#### **Addendum 57 – Regulation No. 58**

#### **Revision 2 - Amendment 4**

03 series of amendments to the Regulation – Date of entry into force: 18 June 2016

#### **Uniform provisions concerning the approval of:**

Figure 1

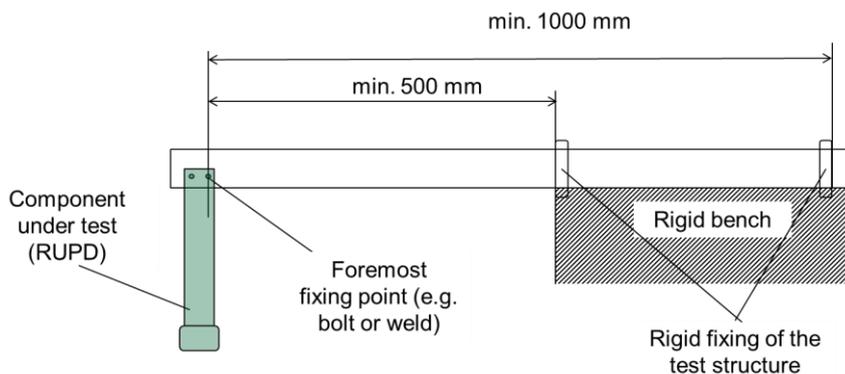
Paragraphs 1.2. and 1.3., amend to read (inserting a new Figure 1):

- "1.2. In the case of paragraph 1.1.2., the parts used to connect the RUPD to part of the vehicle chassis shall be equivalent ... on the vehicle. The part of the chassis can be fixed on a test bench as shown in Figure 1, representing the minimum requirements to be fulfilled. The structures used as side rails shall be representative of the chassis of vehicles for which the underrun protection system is intended.

The distance of the foremost fixing point of the RUPD from the rigid test bench shall not be less than 500 mm. If a diagonal strut is used to support the RUPD, this distance shall be measured between the foremost fixing point of the strut to the side rail structures and the rigid test bench.
